# Physical Interference with SCMs

Slide Package #4

# Physical Interference with SCMs (cont.)

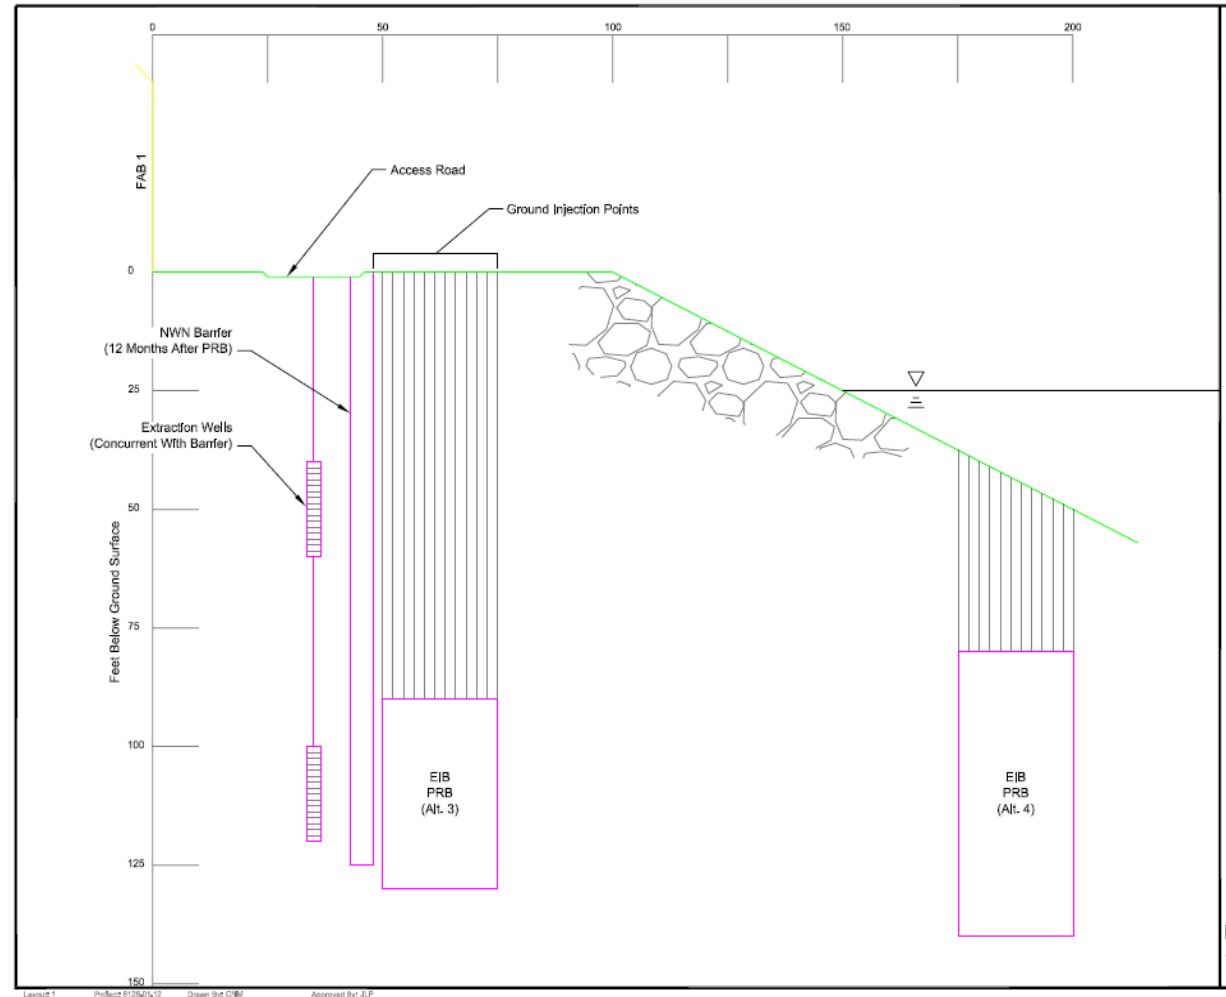
- Minimum dimensions of EIB PRB is 850 feet long by 40 feet deep (~90 to 130 feet bgs) by 25 feet wide (at riverbank)

# Chemical Interference with SCMs

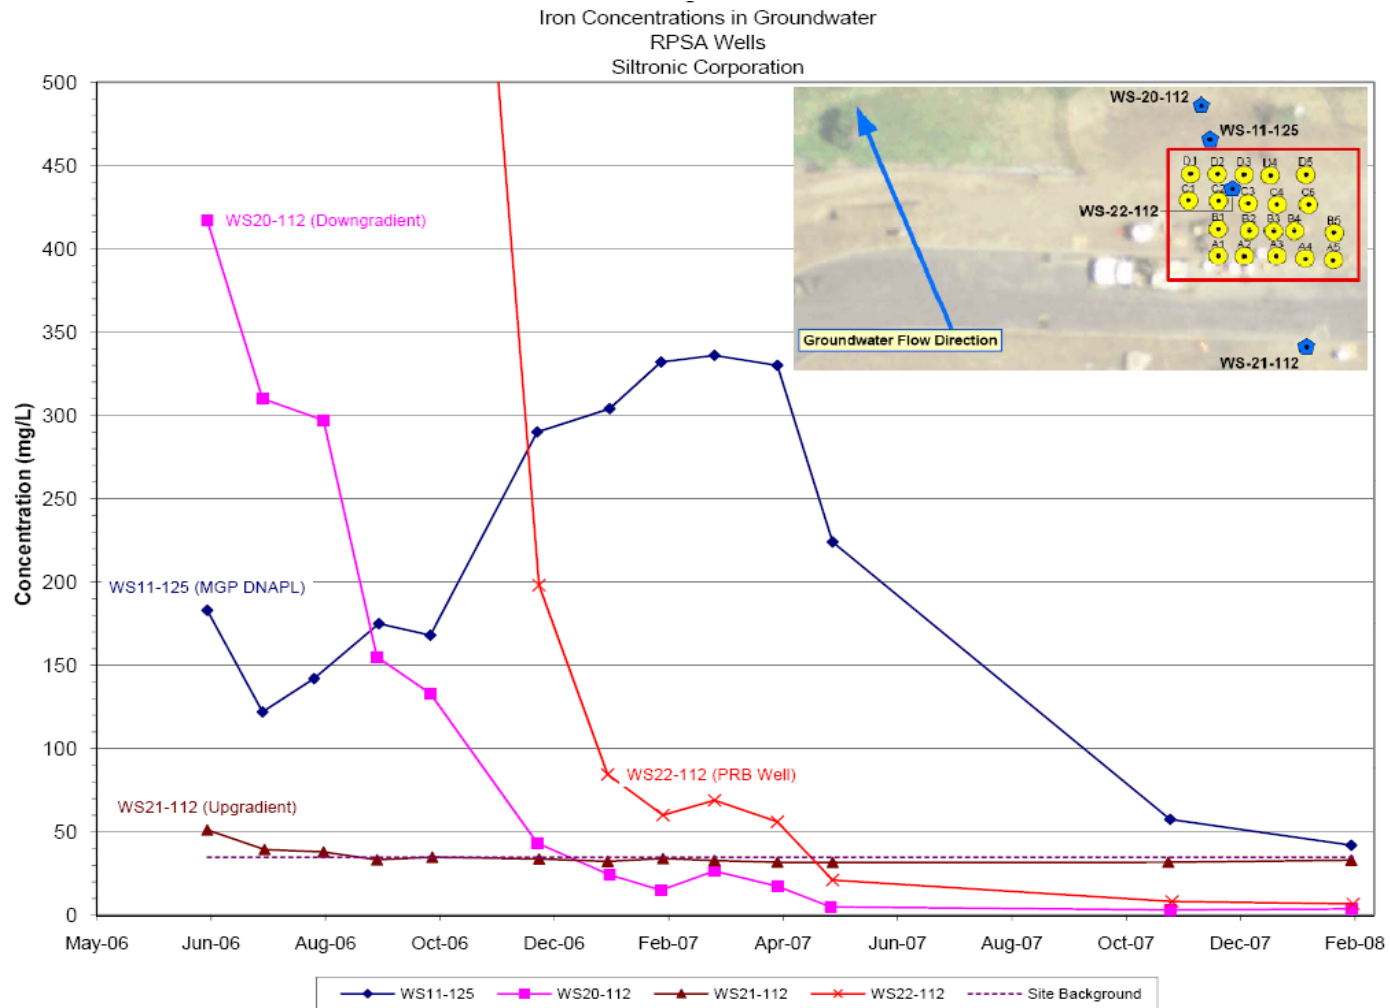
- EHC drives redox down to levels that could influence bentonite-based slurry walls
- Minimum of 300,000 pounds of ZVI needed for EIB
- Inorganic groundwater chemistry significantly altered
  - Ex. Total iron concentrations increased from less than 50 mg/L to over 2,000 mg/L during pilot study
- Depending on location, dissolved iron persists in groundwater above background for at least 16 months
- EHC expected to “actively enhance the bioremediation conditions for a period of 3 to 5 years”
